**PLANNED UNIT DEVELOPMENT
& SUBDIVISION STAFF REPORT****Date: April 5, 2007****DEVELOPMENT NAME**

Lot A of the Oaks Subdivision

CONTEMPLATED USE*Planned Unit Development* to allow a residential subdivision with a gated private road, and *Subdivision* approval to create one (1) lot.**TIME SCHEDULE
FOR DEVELOPMENT**

SITE PLAN

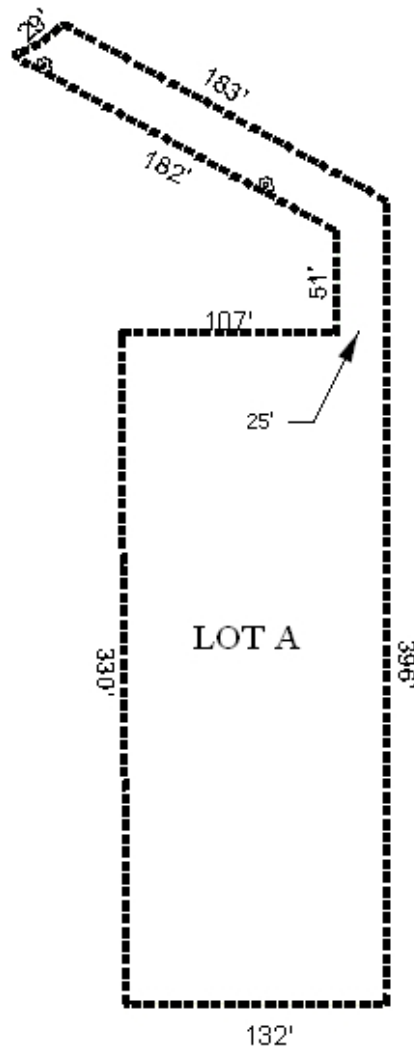
The site currently has no frontage on a public street, however, the applicant proposes to have approximately 25-feet of frontage on a private street that will be created as part of the "Grand Oaks at Hillcrest Subdivision" and PUD. As the application in question proposes a separate PUD from that associated with the Grand Oaks development, there is concern that the site will lack guaranteed access to the private street proposed for the Grand Oaks development. It is recommended, therefore, that the PUD application for "Lot A of the Oaks Subdivision" be combined with the PUD application for the "Grand Oaks at Hillcrest Subdivision."

- 1) amending of the PUD application to be part of the “Grand Oaks at Hillcrest Subdivision” PUD application (including revised area information), and provision of additional labels and postage as necessary due to expanded notification requirements;
